APPROVE JOINT COMMUNITY FACILITIES AGREEMENT
FOR CITY OF INGLEWOOD COMMUNITY FACILITIES DISTRICT NO. 2010-1
CITY OF INGLEWOOD; HOLLYWOOD PARK LAND COMPANY, LLC; AND
LOS ANGELES COUNTY FLOOD CONTROL DISTRICT
(SUPERVISORIAL DISTRICT 2)
(3 VOTES)

This action is to approve the Joint Community Facilities Agreement (JCFA) between the City of Inglewood; Hollywood Park Land Company, LLC; and the Los Angeles County Flood Control District (LACFCD) to allow certain public facilities to be financed by the City of Inglewood Community Facilities District No. 2010-1 and ultimately transferred to, owned, and operated by the LACFCD.

Figure II-4 [REVISED] Preliminary Land Use Plan

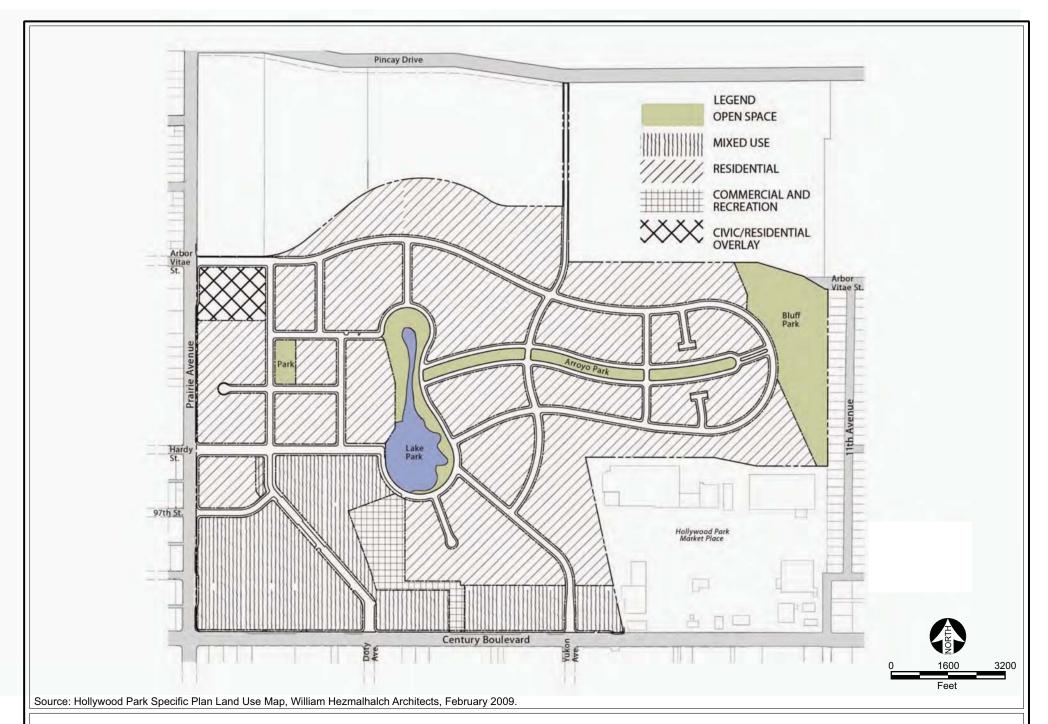
## 8. Figure 11-4 (Preliminary Land Use Plan)

- Figure II-4 Preliminary Land Use Plan This Figure has been revised to include cross hatching overlays instead of shaded overlays to improve the readability of the distinctions between different land use designations. The "Civic Overlay" from the original graphic has been modified to read "Civic/Residential Overlay." No other changes to the land use plan have been made.

Comment noted. The Additions and Corrections Section of the Final EIR has been revised to update Figure II-4 on Page II-9 of the Draft EIR to make the distinctions between land uses more clear.

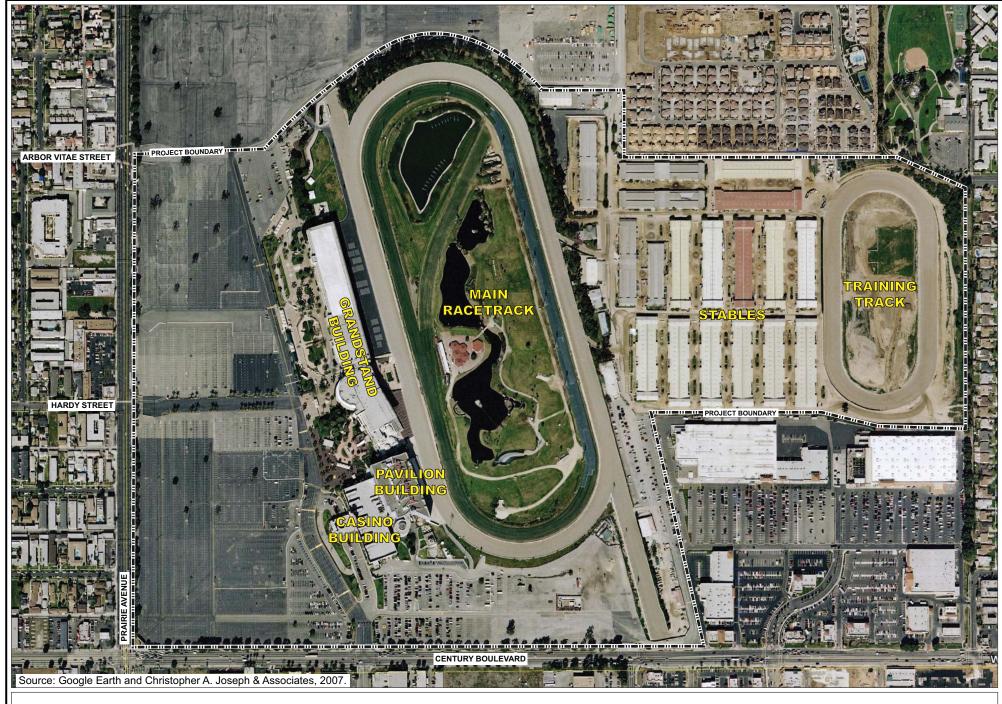
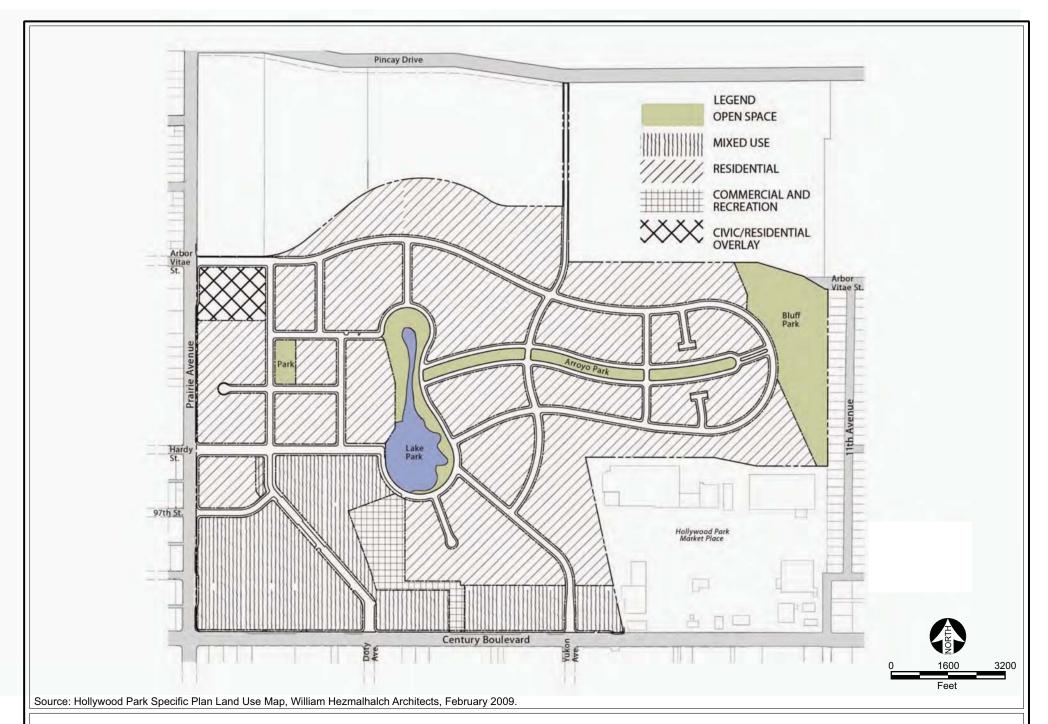
## 6. Figures II-2 and II-3(Aerial Photograph and Existing Site Plan, respectively)

## 7. Figure II-2 (Aerial Photograph)

Figure II-2 Aerial Photograph - This Figure has been revised to be more legible and to correctly label "Arbor Vitae." Arbor Vitae was incorrectly labeled as "Arbor Vista in the Draft EIR.

- Figure II-3 Existing Site Plan This Figure has been revised to be more legible and to correctly label "Arbor Vitae." Arbor Vitae was incorrectly labeled as "Arbor Vista" in the Draft EIR.
